**VILLAGE OF DOWNERS GROVE
COUNCIL ACTION SUMMARY**

Project Title: PC 08-04; Pettit Subdivision Final Plat of Subdivision

TO: Joseph P. Skach, AIA, AICP, Director of Planning & Community Development
FROM: David H. Barber, P.E., Director of Public Works *DHB*
BY: Michael D. Millette, P.E., Asst. Director of Public Works – Engineering *MDM*
Jonathan C. Hall, P.E., Development Engineering Manager *JCH*
DATE: May 27, 2004, 2004
RE: Planning / Zoning Petition for Special Use Amendment
Pettit Re-subdivision (6124 Plymouth → 3 lots)
Public Works Department 3rd Review

ENGINEERING PLAN PETTIT RESUBDIVISION

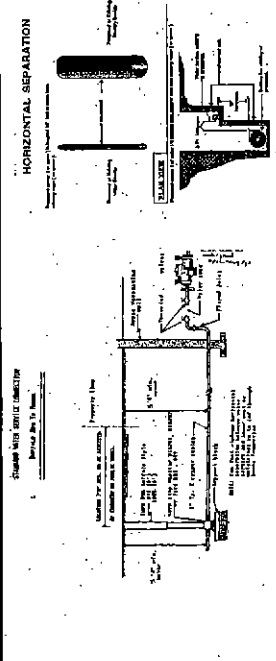
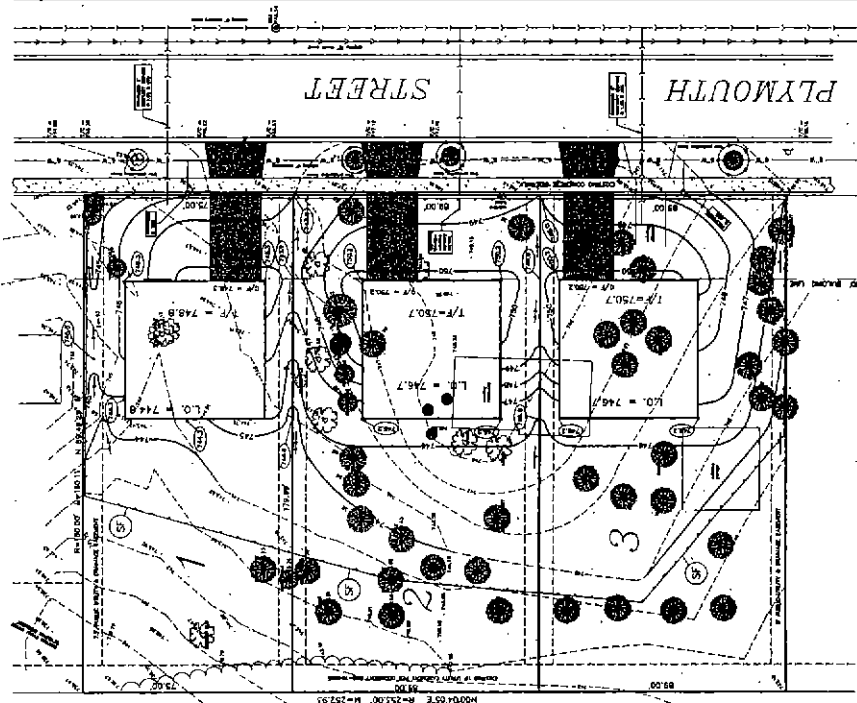
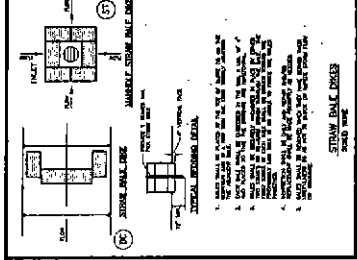
1. Based on a total parcel area of 15,511 square feet, detention would not be required if developed as one residential unit on each of the three proposed parcels.
Accepted

2. Provide a grading plan.
Accepted
3. Show all trees that are planned for preservation on the grading plan, including diameter and species.
Accepted
4. Provide public utility and drainage easements along all side and rear lot lines. The side yard easements must be a minimum of 5 feet in width on each side of the property line (10-foot total width for interior borders). The rear easement should be a minimum of 10 feet in width.
Accepted

5. Provide a wetland delineation by a qualified professional. The DuPage County wetland inventory map shows a wetland area near the west property line. The wetland boundary must be field-verified by the Village's consultant prior to acceptance. Please note that the current snow cover and lack of vegetation do not permit for this verification. If the wetland's presence is confirmed by the Village's consultant, provide a complete wetland submittal per requirements of the DuPage County Stormwater and Flood Plain Ordinance. The wetland and / or buffer could reduce the developable area.
Accepted

6. Provide a topographical survey of the site and all offsite areas within 100 feet. Additional offsite topographical survey data may be needed to establish the overflow / high water elevation of a Localized Poor Drainage Area located near the western property boundary.
Accepted

7. Design the grading plan and conveyance routes, possibly including storm sewers, to maintain wetland hydrology and prevent runoff in significant excess of that which currently drains to adjacent private properties. Rooftop, front yard, and driveway drainage will need to be directed to minimize offsite impacts.
Accepted

8. Provide pre-project and post-project runoff calculations.
Accepted
9. Footing drain sump pump connections to the Village storm sewer may be required.
Accepted

10. Revise the directional flow arrows to be consistent with topography.
Accepted
11. Provide an explanation of how permanent "best management practices" for stormwater quality management are incorporated into the site design.
Accepted
